September 21, 2016

**RE: Comments on MDEQ's Sulfur Dioxide One-Hour National Ambient Air Quality Standard State Implementation Plan Submitted to EPA for Approval**

**Figure 1. Average Background SO<sub>2</sub> Design Values for 2012-2014 Using Allen Park Concentration Data with Varying Excluded Wind Direction Angles**

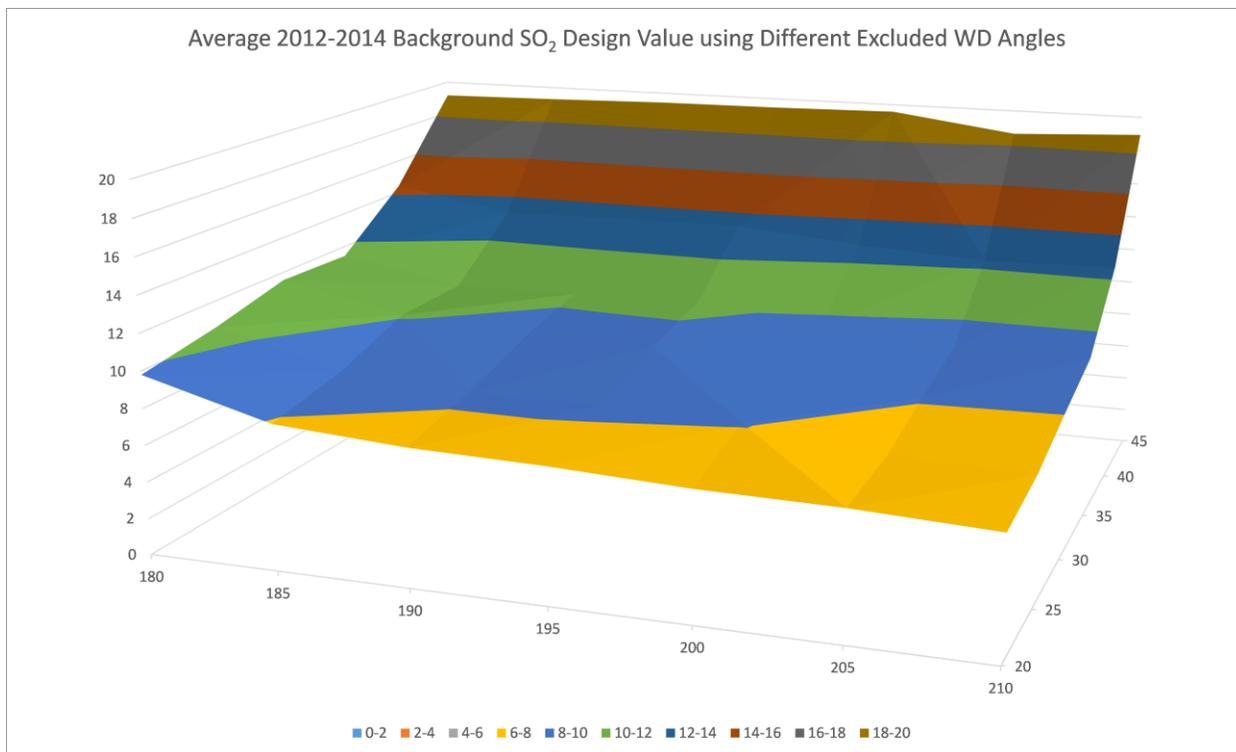
Finally, expanding the range of excluded angles creates too much uncertainty to represent a reasonable approach.<sup>103</sup> The three-year average (2012-2014) design values for various excluded wind direction ranges were plotted by Dr. Gray, see Figure 1 below.<sup>104</sup> The plot shows the three-year average design value for each pair of lower excluded angle (along the right axis) and upper excluded angle (along the lower axis).<sup>105</sup> The plot illustrates the sensitivity of the background design value to the selection of the excluded angle range.<sup>106</sup> This further demonstrates that MDEQ's selection of 40-205 degrees results in a highly uncertain estimate for the background level.
